RECEIPT DATE: 4/3/2025 ONSITE SEWAGE DISPOSAL SYSTEM P 589026

APPROVAL DATE: 6/5/25 PERMIT: REPAIR A Repair

PROPERTY ADDRESS: 3117 Fox Valley Drive

From: Oswald Jr, Woodin <hoswald@howardcountymd.gov>
Sent: Tuesday, March 11, 2025 10:20 AM
To: John Hieatzman
Cc: Chris Berarducci; Wolf, Kevin
Subject: Site plan_3117 Fox Valley Drive
Attachments: Site plan for tank replacement.pdf

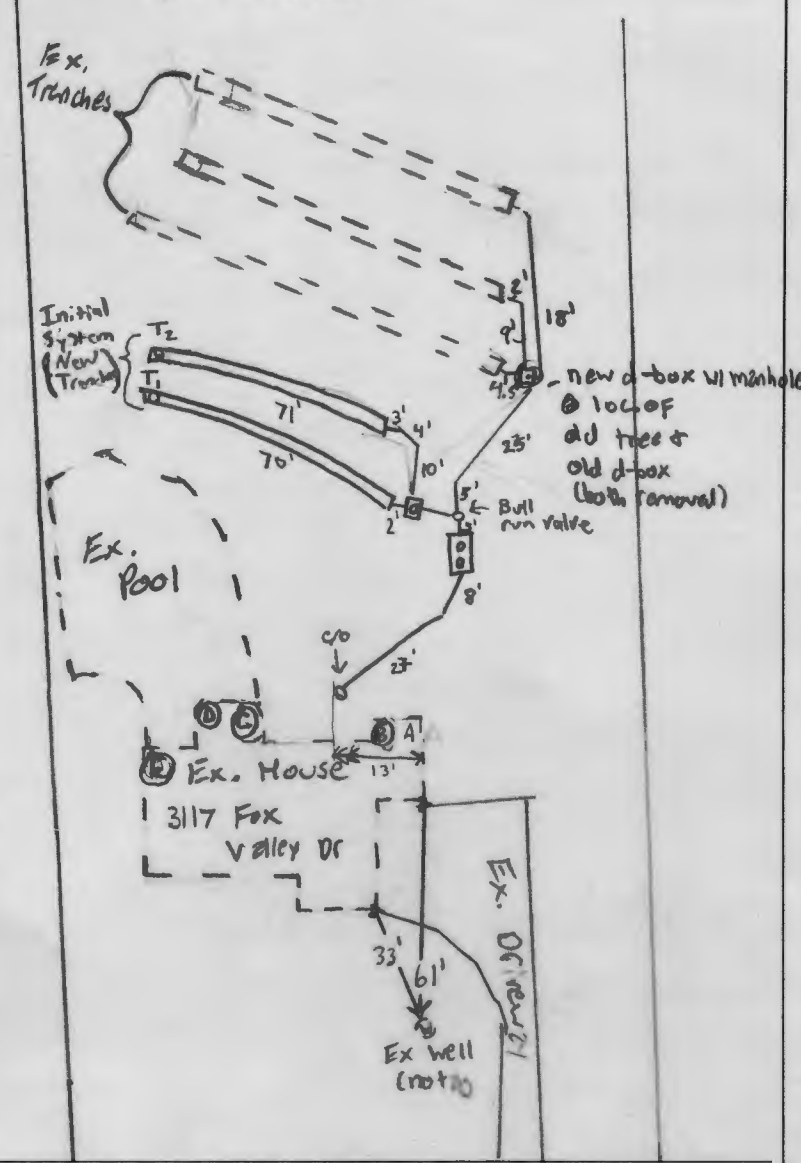
4/6/25 Contractor backfilling site. Riser added to d-box and 4" PVC pipe added for bull run valve.
 Levelled d-box (AB)

INSTALLATION NOTES:
8/30/2025 - installer onsite. tree stump & old d-box removed. installer set new d-box & solid pipe to old trenches. D-box leveled to stop effluent from going into trench 2 (SP)
6/2/2025 - Installer has trench 1 installed. 70' long and inlet at 2.5'. The trench partially caved in where the perc hole was dug in by A large rock also had to be pulled out from the trench. Stone is marginal with some clays and fines. (MB)
6/2/25 Trench 2 completed. Inlet at 2.5' and length 71'. Contractor hit power line running through SDA while digging trenches. He contacted the builder who will replace. Power line is about 1' deep. It is running to a spark controller that is at the back of the property. Distance between trenches 1 and 2 is 9'. Geotextile fabric & obs port installed for both trenches. OK to backfill. (P)
 FINAL INSPECTOR Matthew Burns DATE OF APPROVAL 6/5/25

4/4/25 Contractor gun, crawl, and backfill old septic tank. Tied in to existing front line. Installed cleanout 7 1/2' fall. Septic tank is level
 Contractor to backfill
